Planning Commission Meeting Agenda
Hartland Township Hall
Thursday, August 11, 2022
7:00 PM

Subject: Site Plan #22-009 Charyl Stockwell Academy-Building Addition

RE: Charyl Stockwell Academy – Concept Plan Review Response
SDA Review No. HL22-114
IA Project No. 20220121

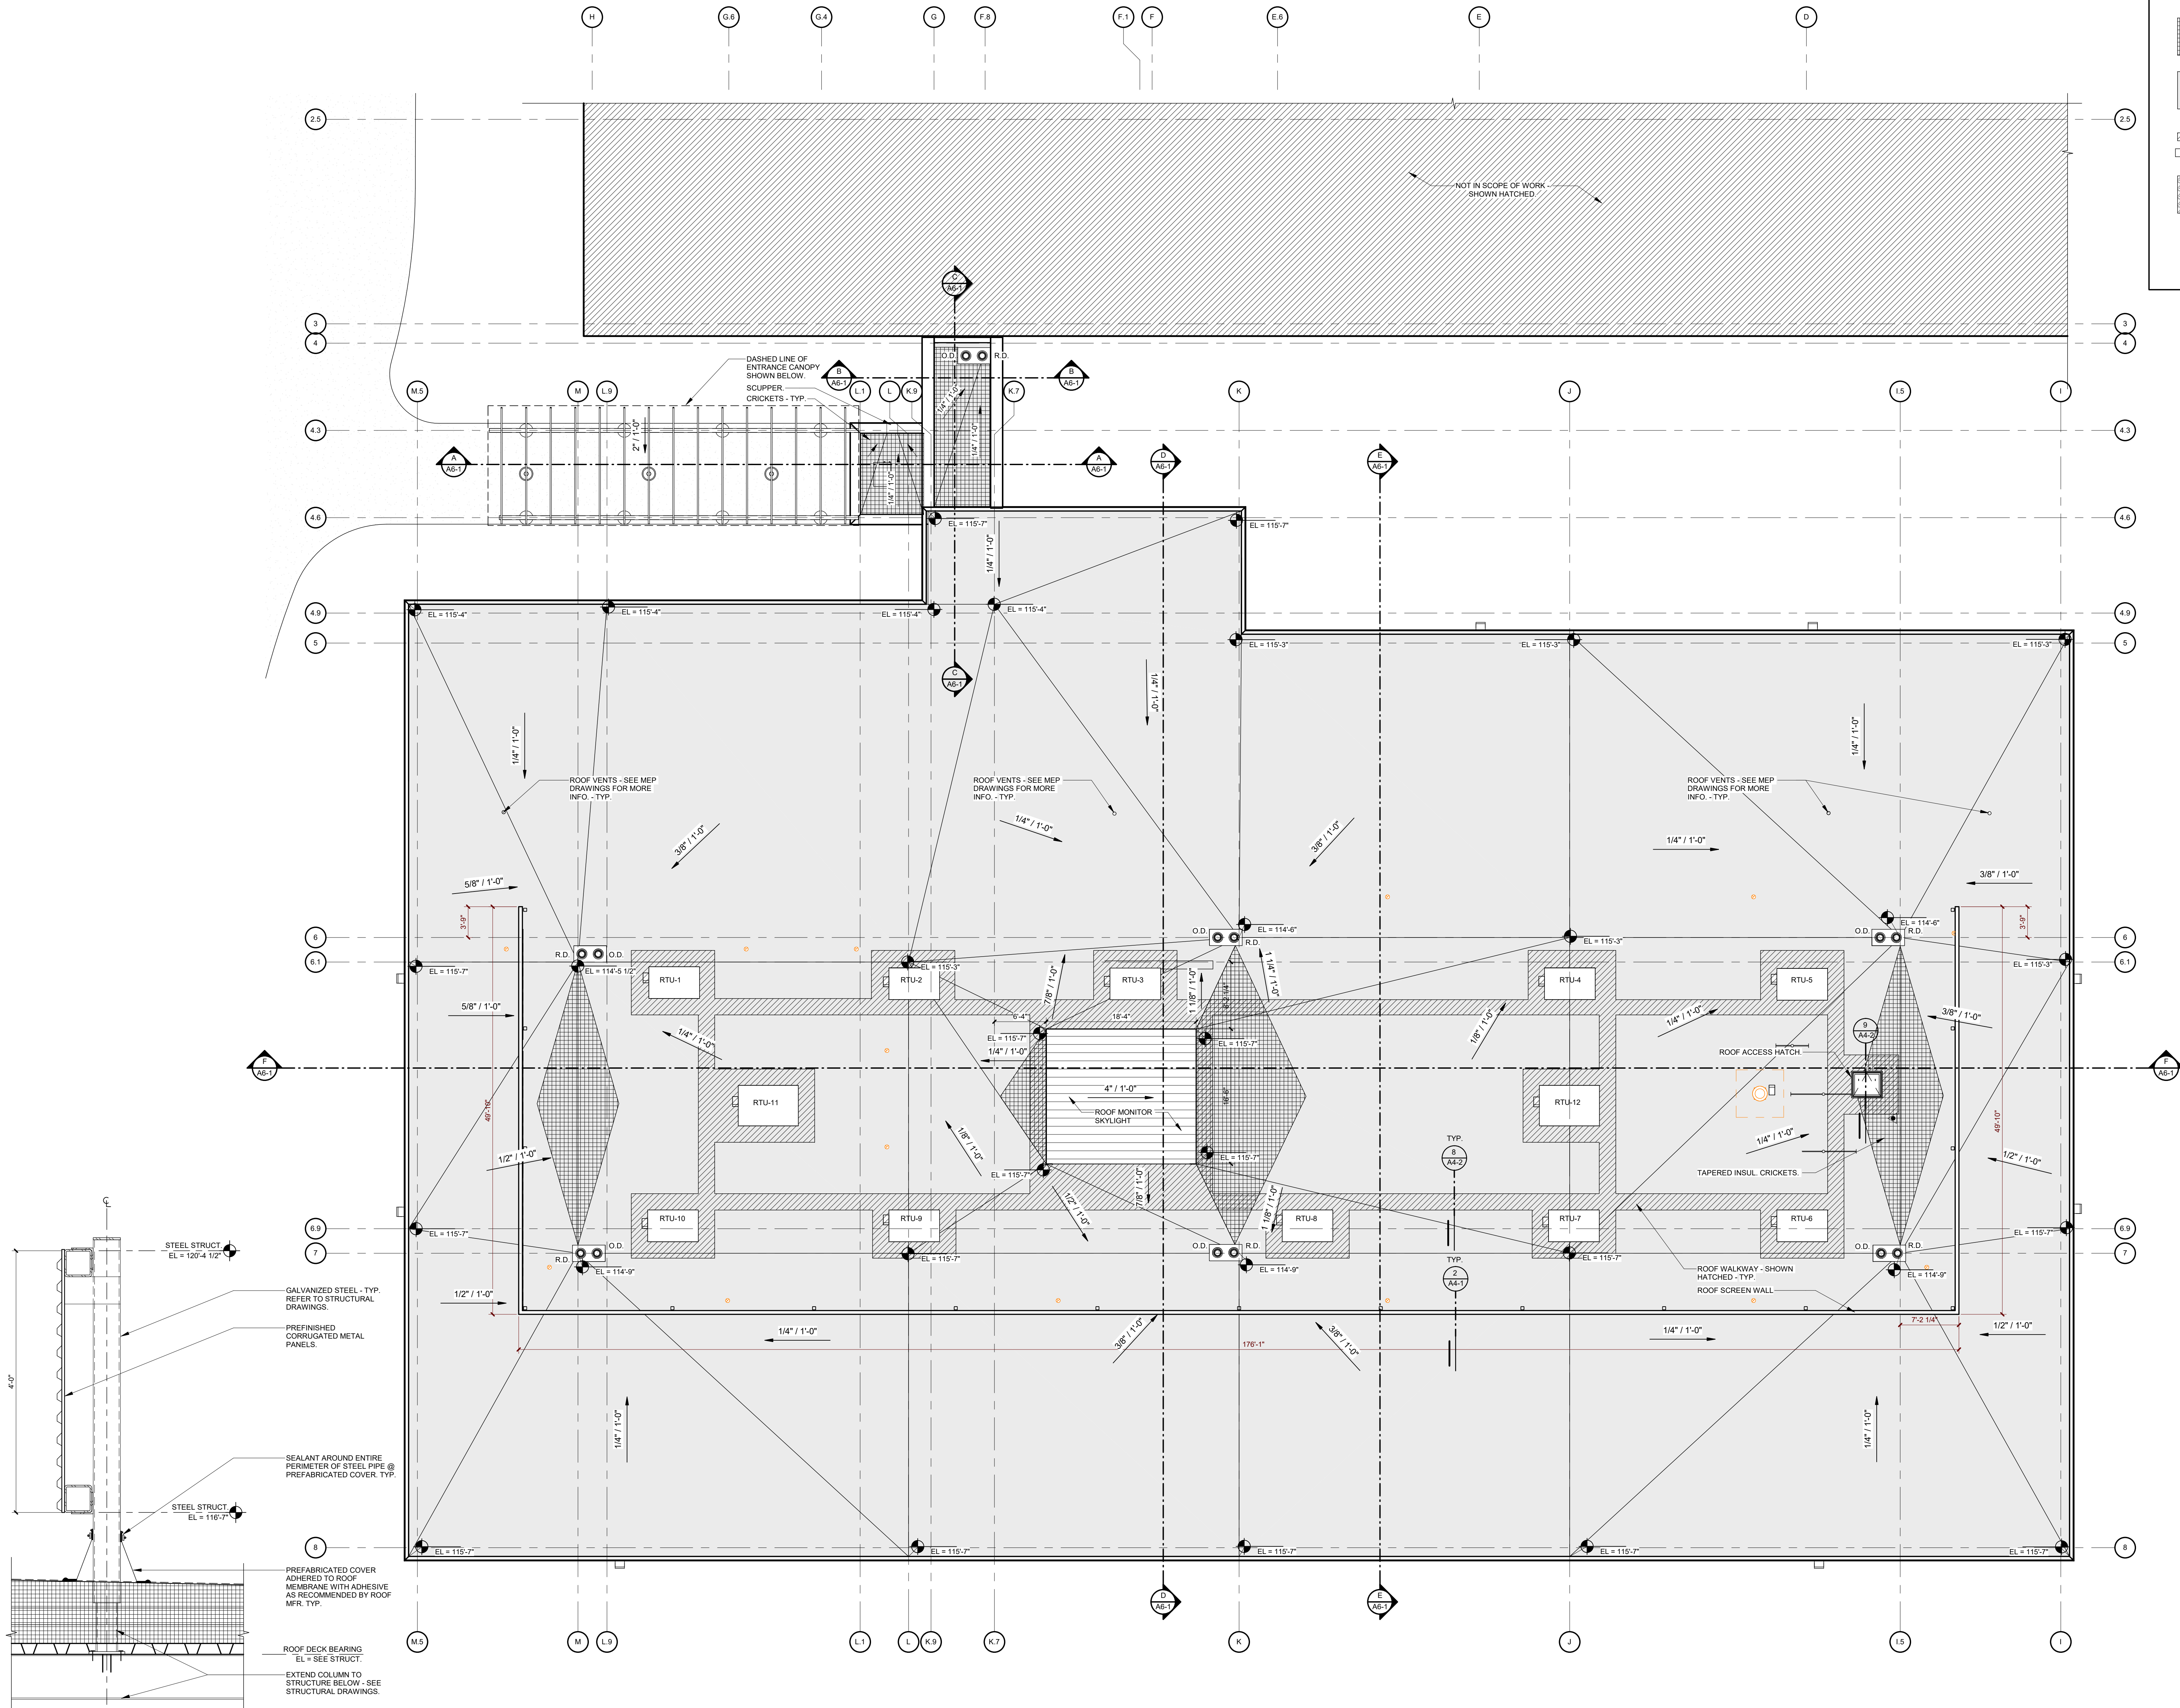
6. Please provide a scaled, detail drawing of the proposed screen wall to be used to screen the RTU's, and state what product(s) are being used.

Response: See sheet A4-1 for section detail.
